**Subject:** MHI's Responses to US-APWR DCD RAI No.794-5871 Revision 0 (SRP 6.5.2)

MHI's Response to US-APWR DCD RAI No. 794-5871 Revision 0

**RAI NO.:** 794-5871 REVISION 0  
**SRP SECTION:** 06.05.02 – CONTAINMENT SPRAY AS A FISSION PRODUCT CLEANUP SYSTEM  
**APPLICATION SECTION:** DCD Section 6.5.2, 15.6.5 and 15A  
**DATE OF RAI ISSUE:** 8/1/2011

Figure 1. Example of Bypass Leakage Pathway

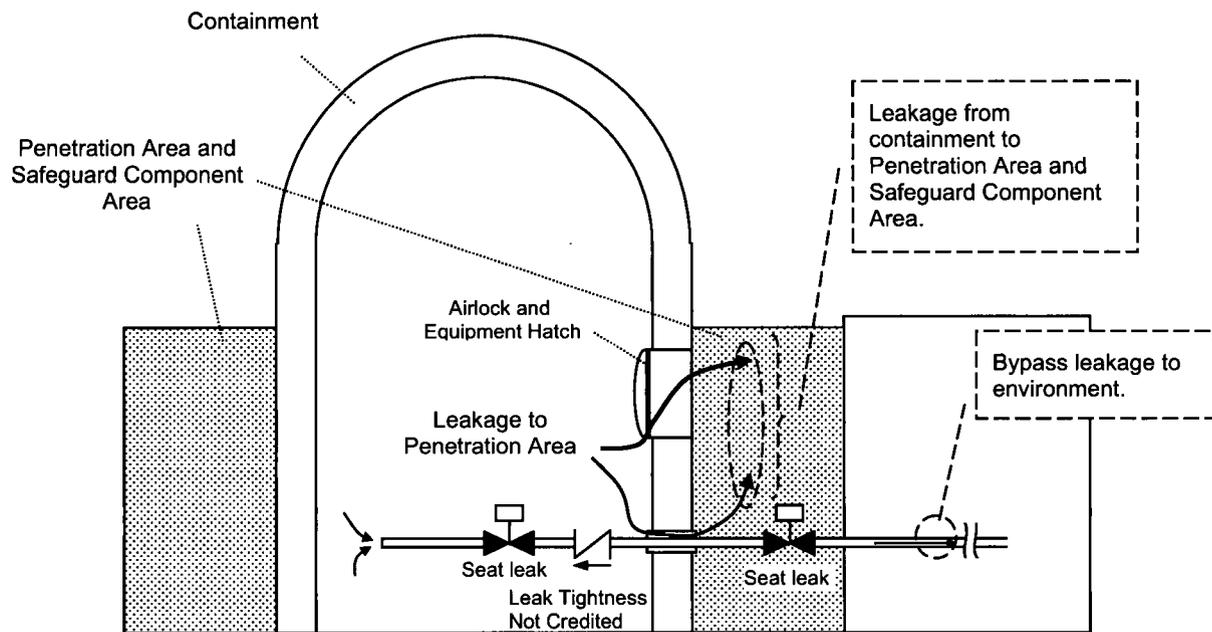
Regarding the realistic dose analysis modeling of containment leakage provided in the response to RAI 715-5262, Question 06.05.02-9:

- a. Provide the basis and/or rationale for the assumed percentage of direct environmental leakage (bypass of secondary containment and filtration),
  - b. Provide a reference for, or a derivation of, the time-dependent containment leak formula.
-

The pipes which penetrate containment have isolation valves, and the containment atmosphere during a LOCA is prevented from being released to the environment.

The containment concrete shell inner surface is lined with a minimum 1/4-in. carbon steel plate that is anchored to the concrete shell and dome to provide the required pressure boundary leak tightness. Therefore, it is expected that leakage from containment occurs through piping and other penetration areas, which are enclosed by the Penetration Area and Safeguard Component Area (PASCA). In general, leakage from containment to other areas is expected to be negligible because of high levels of quality assurance in construction and periodic inspections and leakage testing of the containment volume and penetrations.

All containment penetration parts are enclosed by the PASCA. Therefore, all leakage through penetrations enters the PASCA. The Engineered Safety Features Ventilation system maintains the PASCA at negative pressure during design basis accidents, thereby preventing the leakage from traveling to other areas.

Leakage released to the environment in the US-APWR design was calculated assuming all leakage to the PASCA is released to the environment until these areas attain negative pressure, which occurs in about 4 minutes. Bypass leakage (bypassing the PASCA and passing through to the environment) was

calculated for the installed piping penetration parts without crediting the airtightness of piping penetration components. Bypass leakage was assumed from isolation valves on these pipes and calculated using specified design-basis limits for the US-APWR design. Based on BRANCH TECHNICAL POSITION 6-3 Rev.3 (Ref. 1), leakage from piping penetrations which consist of closed systems was excluded from the bypass leakage calculation.

Calculated bypass leak rate corresponds to about [ ] of total containment leak rate. And, this is sufficiently less than [ ] of total containment leak rate<sup>\*1</sup>.

\*1 Even though calculated bypass leakage might be changed as the US-APWR design progresses, containment leak rate is designed so that bypass leakage does not exceed [ ] of containment leak rate.

From discussion above, direct bypass leakage from containment to the environment is assumed to be [ ] of containment leak rate in the realistic dose analysis.
